_
Model: Iris2/Lilac2 Da			Dat	e: 24-Nov-00	No.: RB017001	
Subject: Relay F			Prepared by: N.	Kaiya		
From: Technical Services Dept., GTS Division						
Classification:	☐ Troubleshooting	☐ Part inf	orma	tion 🖂 Actio	n required	
	☐ Mechanical	☐ Electric	al	☐ Servi	ce manual revision	
	☐ Paper path	☐ Transm	it/rec	eive	fit information	
	☐ Other ()

Model: Iris2/Lilac2

Technical Bulletin

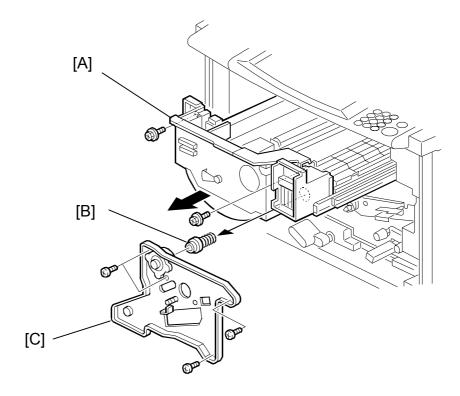
Please note the following when removing and installing the drawer unit.

When removing the drawer unit [A], remove the spring and its holder [B] when detaching the transfer belt unit stay [C]. Otherwise, the spring and its holder can drop out when the drawer unit is pulled out. In addition, the spring and holder may spring out when the drawer unit is pushed in at unit installation.

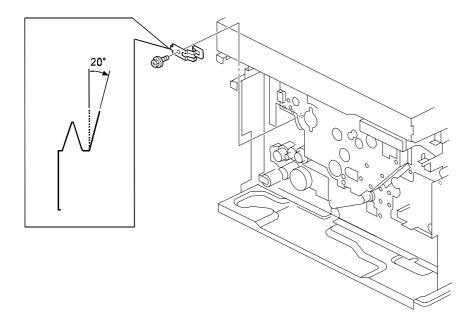
SC301, SC302 or SC360 may occur while making copies.

Poor contact between the grounding plate and PCC casing can cause an electrical leak and/or noise.

The grounding plate was modified as shown above and applied to the production line from May, 2001.

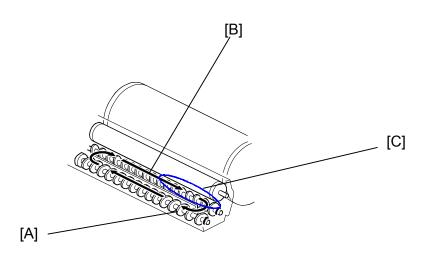
Image density on the operator side is lower than on the non-operator side.

- 1. The toner weight percent around the area [C] inside the development unit decreases during continuous development of images containing a percent of solid image areas (copier/printer).
- 2. The developer's chargeability decreases prematurely.

- [A]: Toner is supplied from the toner hopper around this area.
- [B]: During this toner flow (non-operator side to operator side), toner is consumed for image development.

- 3. Be sure to replace the developer at every lifetime cycle (60kD for K, 45kD for C, M, Y). This is to ensure that the developer properties remain within normal operating parameters.
